March 3, 2011

**Re: Deer Creek Auto Parts / Pickaway County
Industrial Storm Water Permit 4GR00028*DG**

This letter is written in regard to the storm water inspection that I conducted at Deer Creek Auto Parts, located at at 611 East Mill Street, Williamsport, Ohio. The inspection was conducted on February 15, 2011, to determine compliance with your industrial storm water permit. Your facility dismantles automobiles for parts salvage. The following items were noted during the inspection:

Deer Creek Auto Parts
Elevated storage tank w/o containment
Staining on ground
Scioto River Watershed
February 15, 2011
Photo by: Greg Sanders

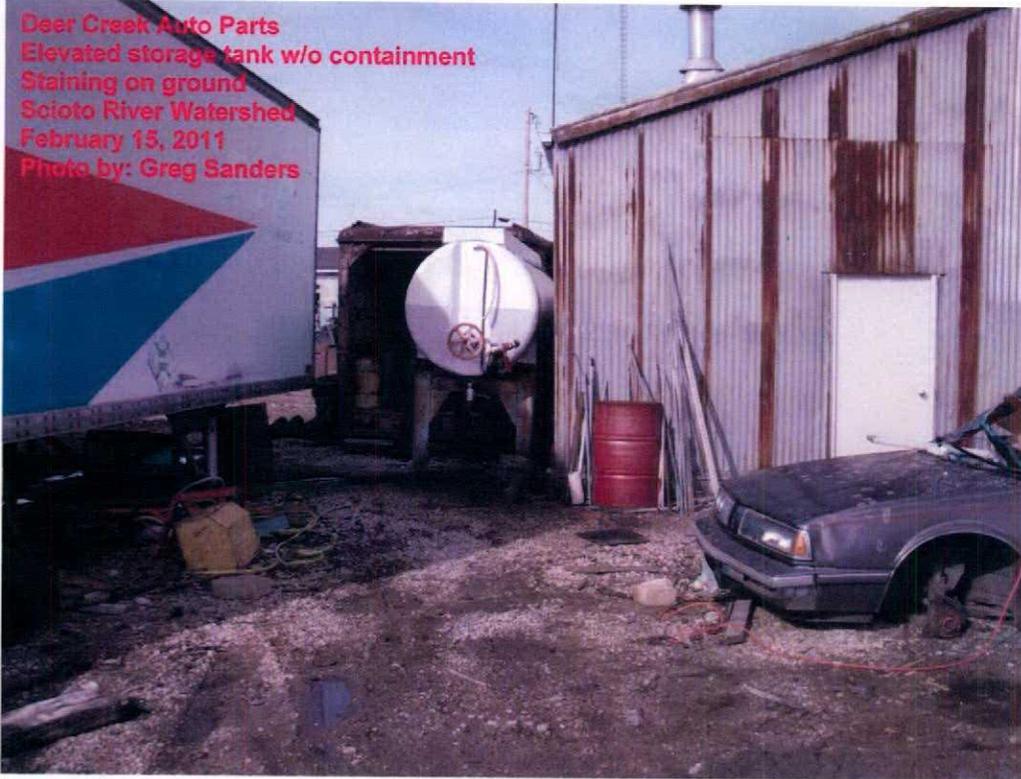
1. Your facility had several fuel tanks and most had secondary containment. However, one elevated tank did not have secondary containment and had oil staining on the ground and an open bucket of oil near it. Please remove the elevated tank or provide secondary containment. Also, please put lids on all open buckets or drums. Please see attached pictures.

Deer Creek Auto Parts
Open & full barrel needs plug & containment
Schofo River Watershed
February 15, 2011
Photo by Greg Sanders

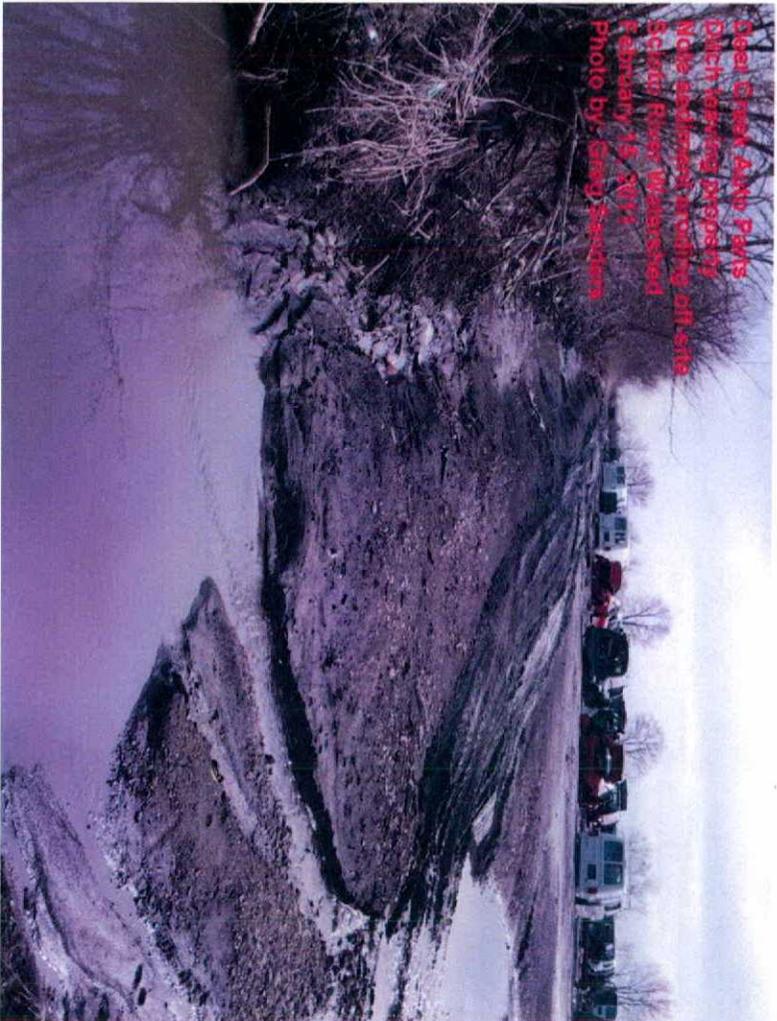
2. There were drums with fluids stored near the rear of the office building. Drums with fluids must be enclosed and stored in secondary containment under roof. Please see attached pictures.
